SUBJECT: COMANCHE PEAK NUCLEAR POWER PLANT, UNITS 3 AND 4
DOCKET NUMBERS 52-034 AND 52-035
RESPONSE TO REQUEST FOR ADDITIONAL INFORMATION NO. 4760

RAI NO.: 4760 (CP RAI #171)

SRP SECTION: 03.07.02 - Seismic System Analysis

QUESTION NO.: 03.07.02-17

Figure 1 – Comparison of Design Response Spectra to the UHSRS In-Structure Response Spectra at Basin Slab

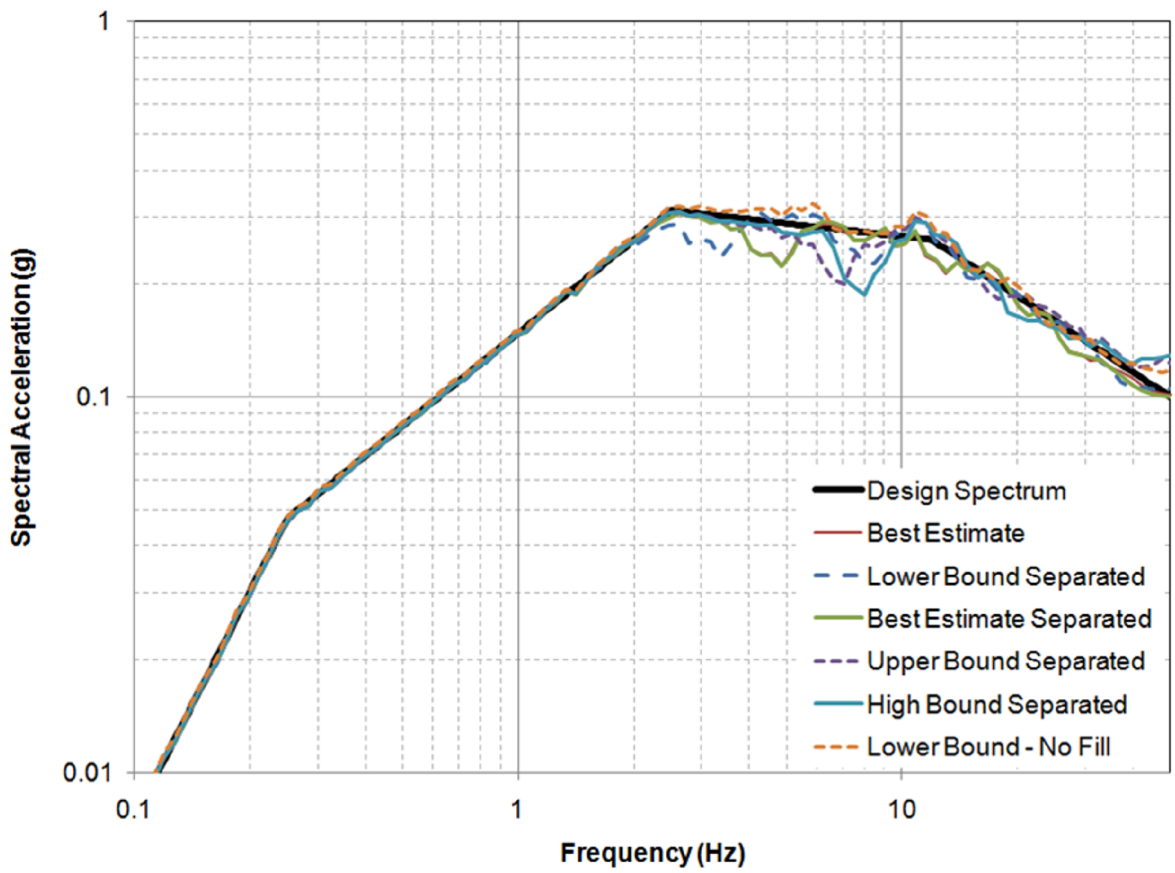
The applicant is requested to discuss the potential impact of the nearby slopes indicated in the site profiles on the computed SSI responses to ensure that the computed seismic responses will not be under-estimated at some frequencies of interest.

Specifically, the staff would like to know how the Squaw Creek Reservoir slope may affect the SSI analysis and the stability of Unit 3 ultimate heat sink (UHS) structures, which are located near the reservoir slope, as shown in FSAR Figure 2.1-201.

The results of the SSI analyses indicate that the SSI effects on the response of the UHSRS are not significant because the limestone layer upon which all UHSRS are founded is relatively stiff. Figure 1 below presents the in-structure response spectra (ISRS) obtained from the SSI analyses of the UHS basin foundation slab for the best estimate and lower bound no-fill cases and for the embedded cases (lower bound separated, best estimate separated, upper bound separated, and high bound separated), together with the horizontal input design response spectra. The ISRS are similar to the design input response spectra except that the results of the embedded foundation SSI analyses show reductions of the amplitudes at the backfill soil column frequencies where the backfill influences the rock in-layer response spectra, thus indicating that the SSI effects on the seismic response of the UHSRS are small. As a result, responses of the UHSRS are not considered to be sensitive to variations in the surface geometry or properties of the limestone due to the presence of the reservoir. Therefore, the presence of the reservoir slope does not impact the SSI results, and the use of a horizontally-infinite half-space and consideration of a broad range of embedment conditions ensures that the ISRS results envelope the actual site conditions.
